## **USB ENGINEERING CHANGE NOTICE**

**Title: Clarification on the Chamfer on USB 2.0 Micro Connectors**

**Applies to: MicroUSB Specification to the USB 2.0 Specification,  
Revision 1.01**

Figure 4-9 Micro-AB receptacle interface

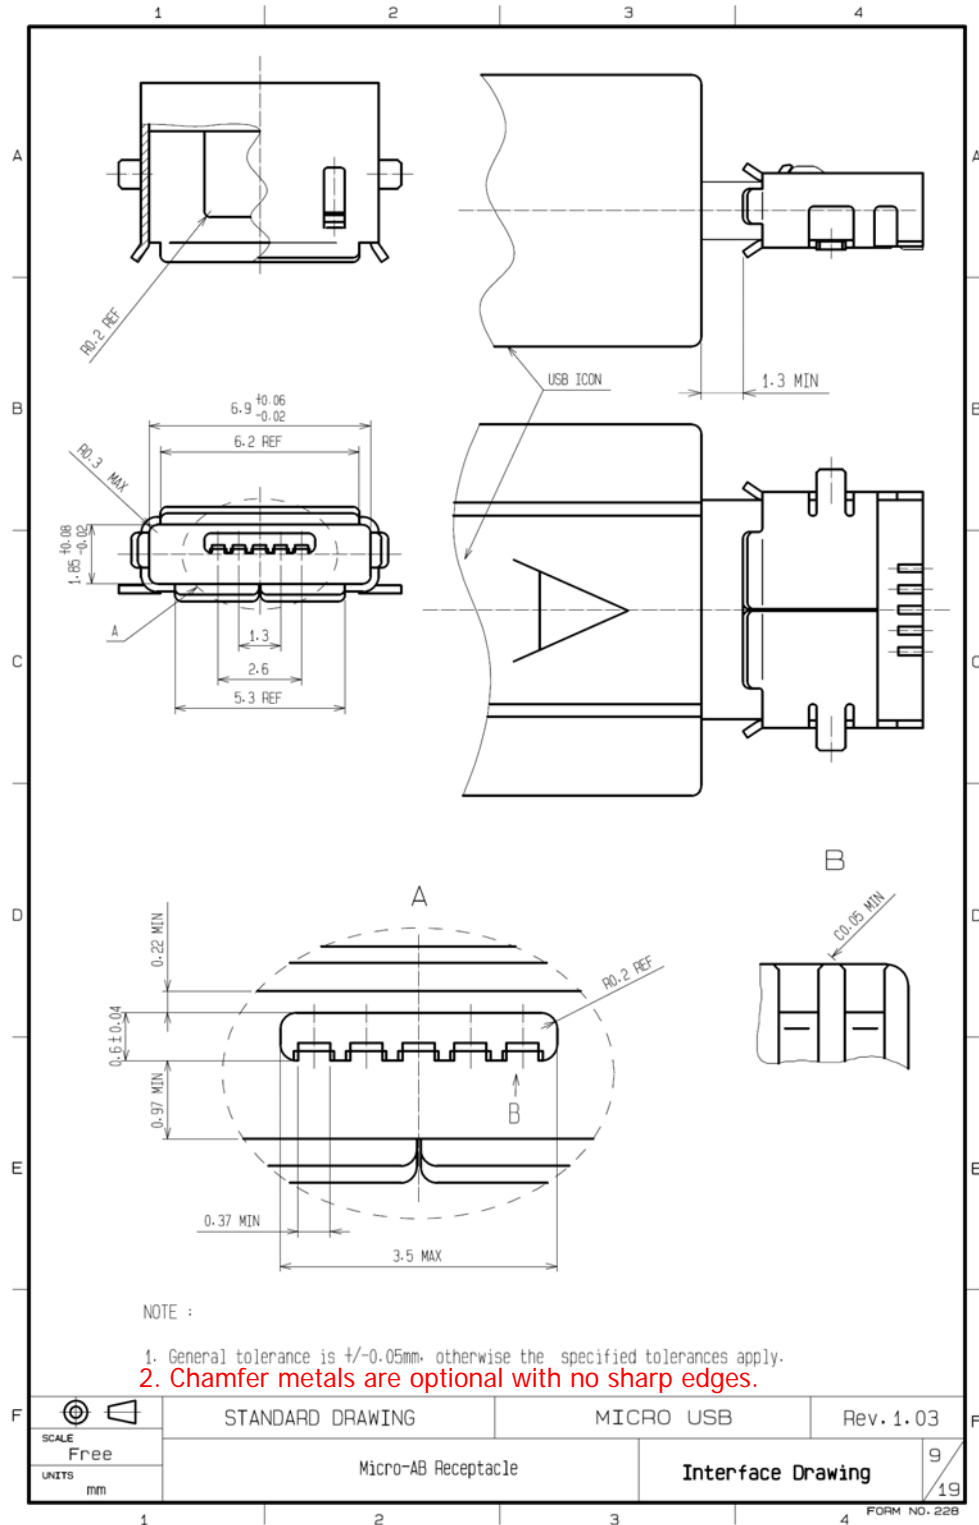
The ECR proposes to add a note "Chamfer metals are optional with no sharp edges." to the Figure 4-9 Micro-AB receptacle interface on the page 24 and to the Figure 4-10 Micro-B receptacle interface on the page 25 as shown in the following pages.
